Detonation Sensor and Module – 1993 200 Magnum EFI/XRi

1993 Mariner 200 Magnum EFI
1993 Mercury 200 XRi
S/N 0D239648 thru 0D270353

Mariner and Mercury
200 and 220 EFI Models
S/N 0D239647 and below
with Replacement Gray Detonation Sensor Installed.

Figure 1. Detonation Sensor

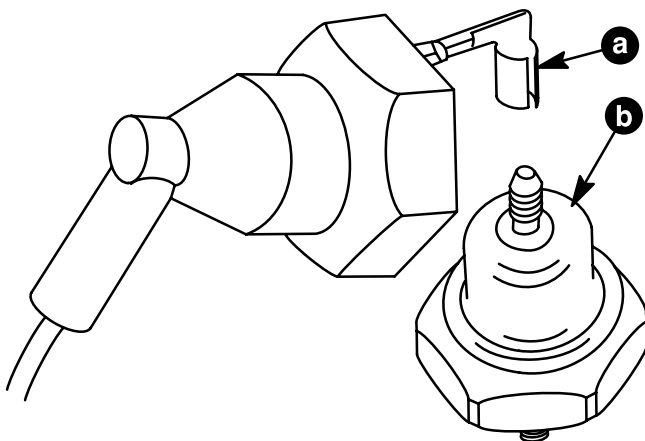
Models listed require installation of an improved detonation module p/n 14856A11 (stamped 14856A10). Beginning with serial number 0D239648 a detonation sensor with a gray dome was installed on 200 Magnum EFI and XRi models. The previous detonation sensor with a black dome is no longer available. We have found that some outboards with the new gray sensor and the 14856A5 or the A8 detonation module may be operating in the “detonation” mode at engine speeds above 5500 RPM. The result of operating in this false detonation mode is a varying degree of reduced performance and possible high fuel consumption.

The improved detonation module eliminates the false “detonation” signal and is compatible with either the previous black or the new gray detonation sensor.

On models listed, remove the detonation module stamped 14856A5 or 14856A8 and install a service replacement detonation module p/n 14856A11 (stamped 14856A10).

Figure 2. Detonation Sensor Location

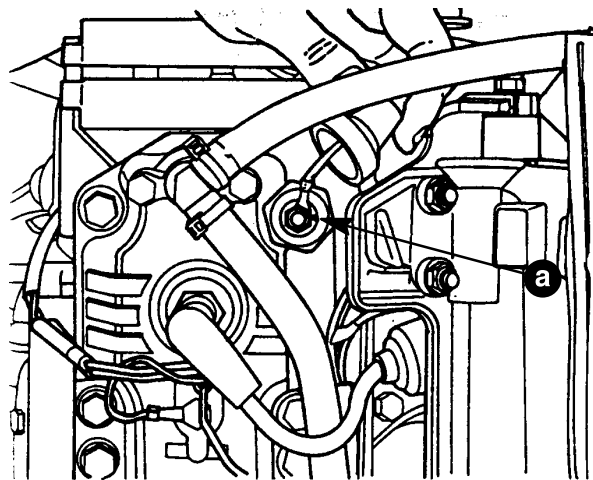
Detonation Sensor The previous detonation sensor p/n 13192 is not available from our supplier and is superseded to p/n 825164A-1 detonation sensor kit.

- careful handling. The sensing element is fragile. A hard blow or dropping on a hard surface can destroy the sensing element.
- a proper torque when installing it in the cylinder head bolt. Sensor torque is 144 in. lb. (16.2 N-m). Over torque can destroy the sensing element.
- a secure wire connection to sensor terminal. The push-on split wire connector (Figure 1) may spread open when removing the connector from the sensor. It may be necessary to squeeze the split end of the connector to ensure a secure connection.

Figure 3. Detonation Module Location

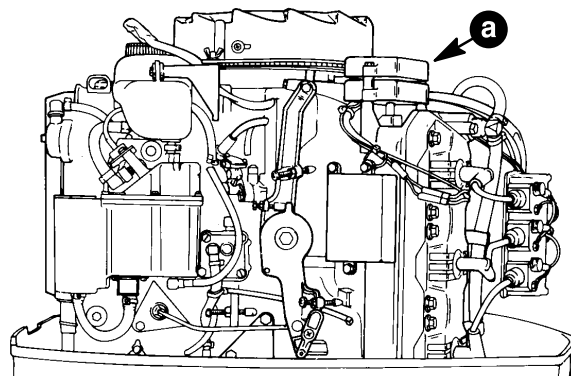
Detonation Module The previous detonation module service replacement p/n 14856A3 supersedes to p/n 14856A11.
